Appendix B Bowes Controlled Parking Zone Extended Zone Boundary - April 2019

Revision Note - April 2019
Area of permit sales to be extended, as per hatching, to cover residential premises between 13 and 161 Green Lanes, inclusive.

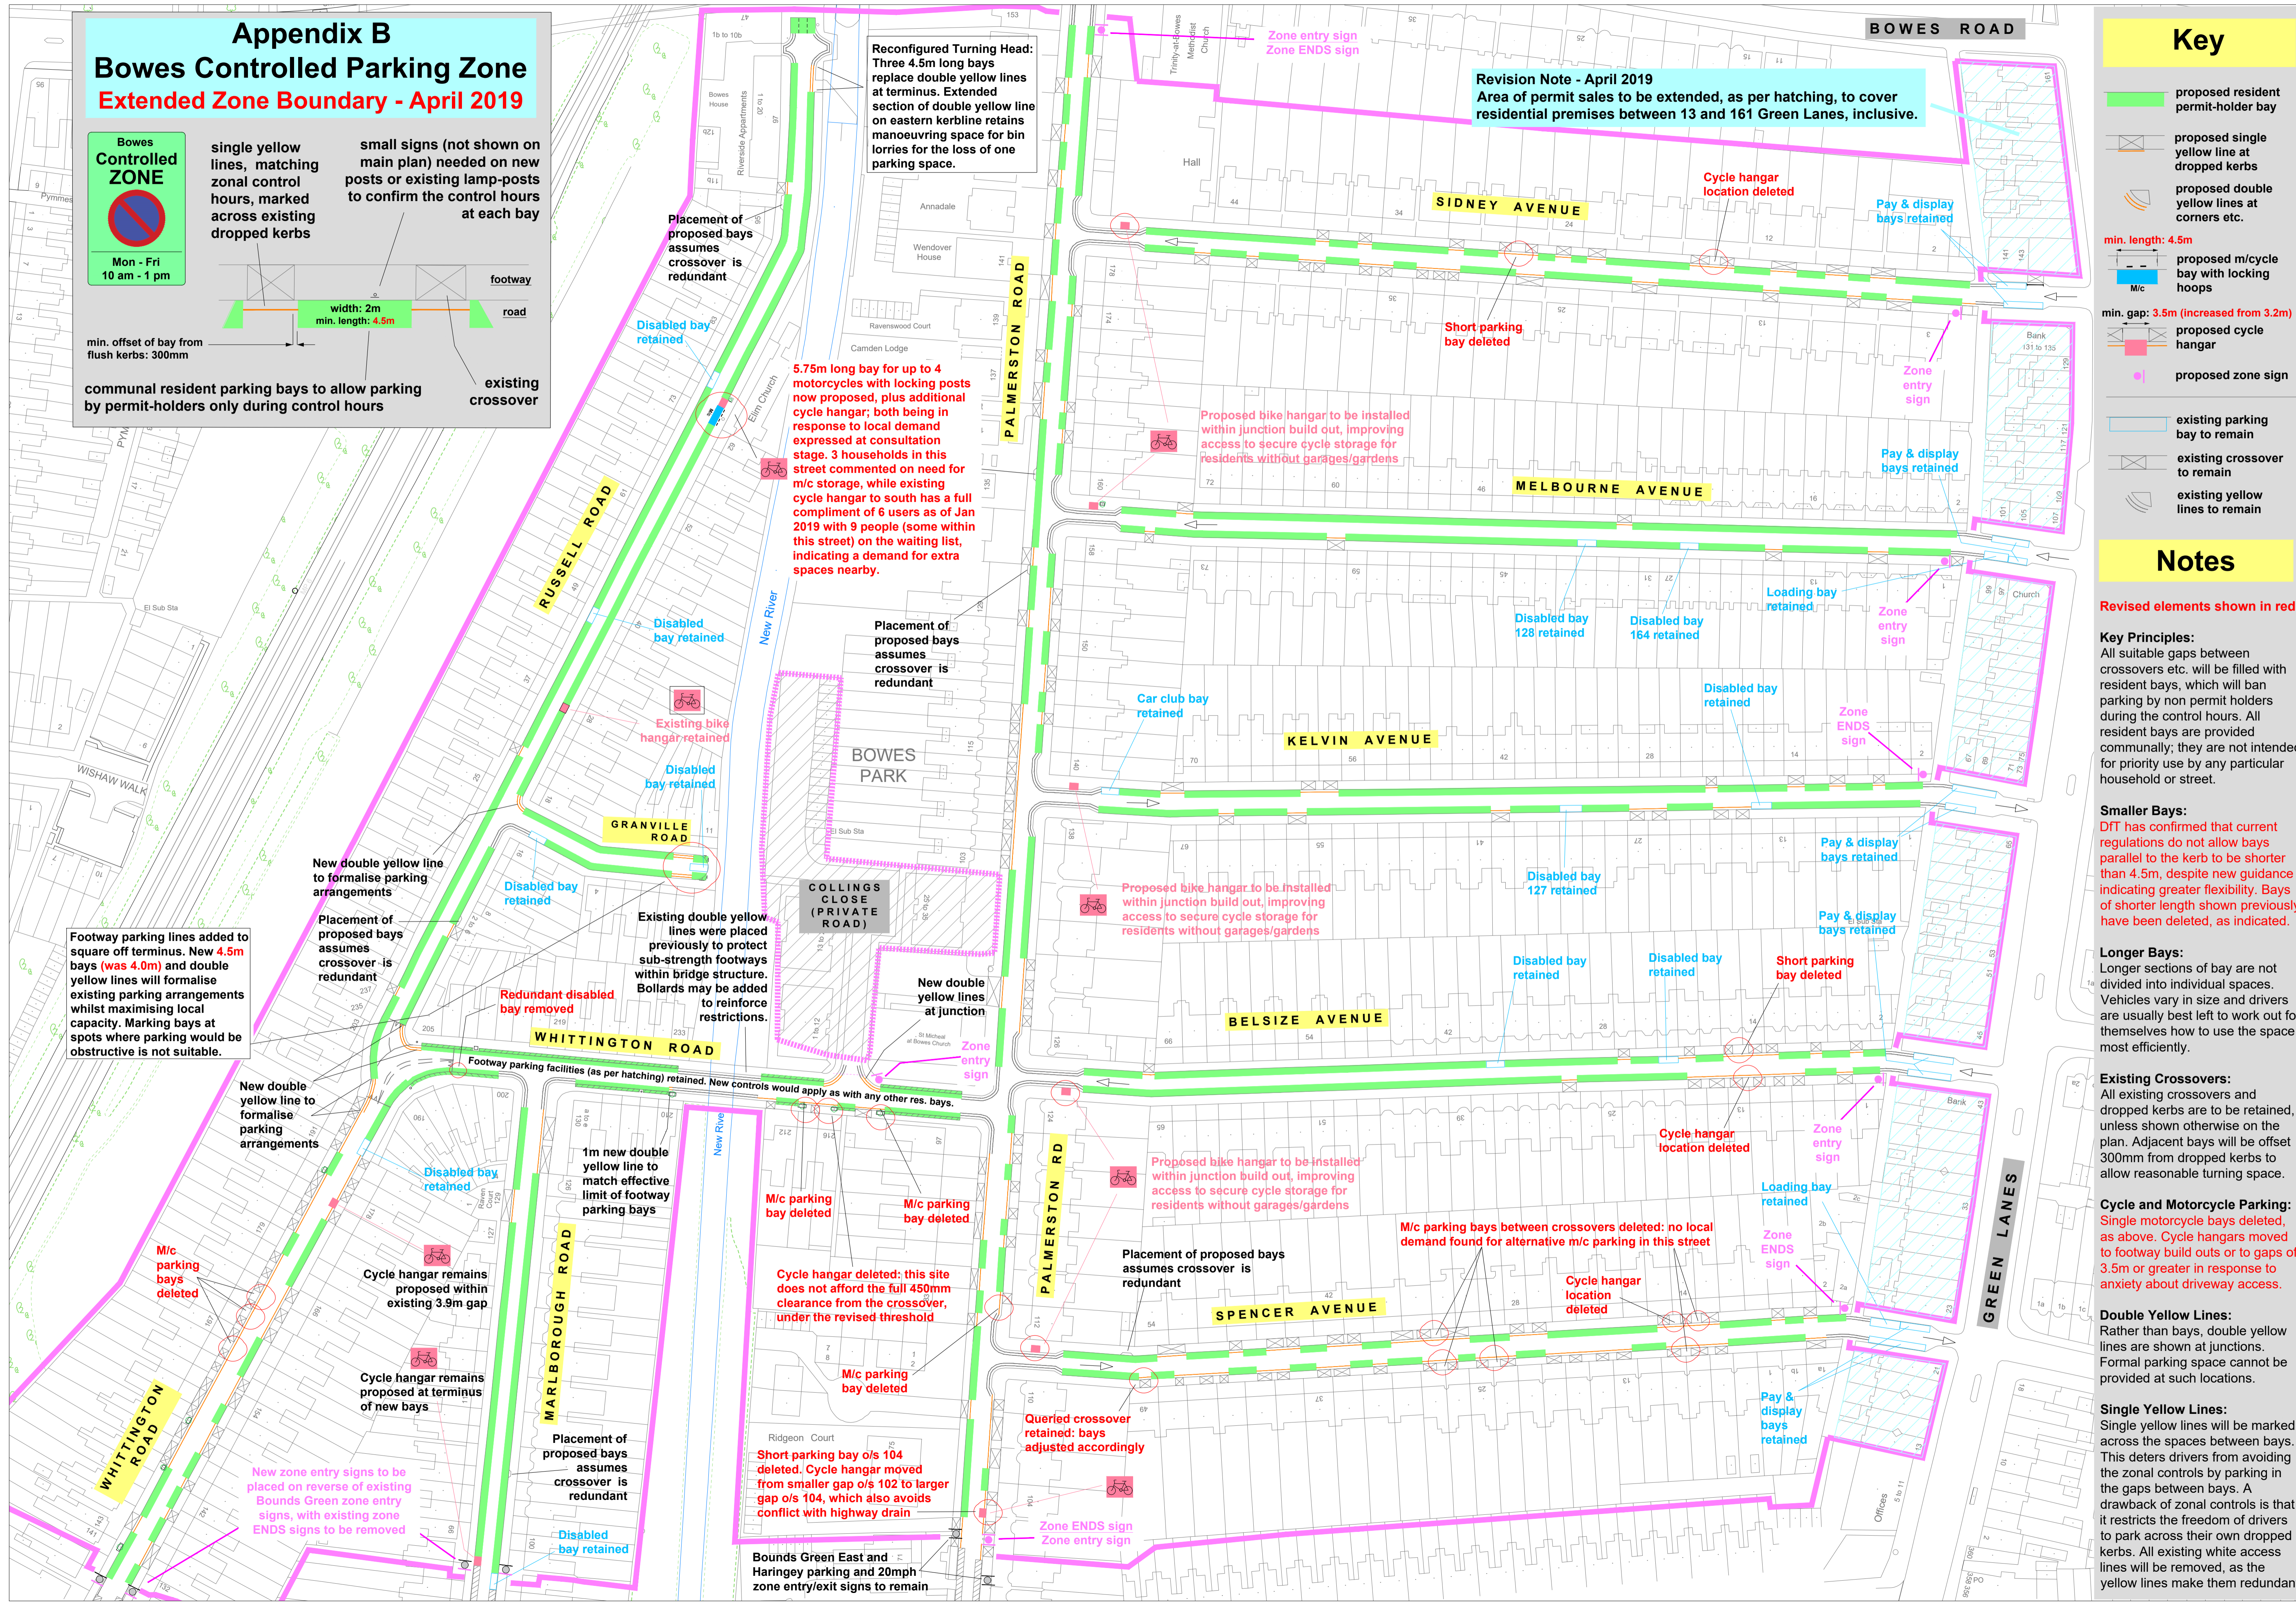
Reconfigured Turning Head:
Three 4.5m long bays replace double yellow lines at terminus. Extended section of double yellow line on eastern kerbside retains manoeuvring space for bin lorries for the loss of one parking space.

5.75m long bay for up to 4 motorcycles with locking posts now proposed, plus additional cycle hangar; both being in response to local demand expressed at consultation stage. 3 households in this street commented on need for m/c storage, while existing cycle hangar to south has a full compliment of 6 users as of Jan 2019 with 9 people (some within this street) on the waiting list, indicating a demand for extra spaces nearby.

Footway parking lines added to square off terminus. New 4.5m bays (was 4.0m) and double yellow lines will formalise existing parking arrangements whilst maximising local capacity. Marking bays at spots where parking would be obstructive is not suitable.

M/c parking bay deleted

Cycle hangar deleted: this site does not afford the full 450mm clearance from the crossover, under the revised threshold

M/c parking bay deleted

Short parking bay o/s 104 deleted. Cycle hangar moved from smaller gap o/s 102 to larger gap o/s 104, which also avoids conflict with highway drain

Queried crossover retained: bays adjusted accordingly

M/c parking bays between crossovers deleted: no local demand found for alternative m/c parking in this street

Cycle hangar location deleted

Smaller Bays:
DfT has confirmed that current regulations do not allow bays parallel to the kerb to be shorter than 4.5m, despite new guidance indicating greater flexibility. Bays of shorter length shown previously have been deleted, as indicated.

Cycle and Motorcycle Parking:
Single motorcycle bays deleted, as above. Cycle hangars moved to footway build outs or to gaps of 3.5m or greater in response to anxiety about driveway access.
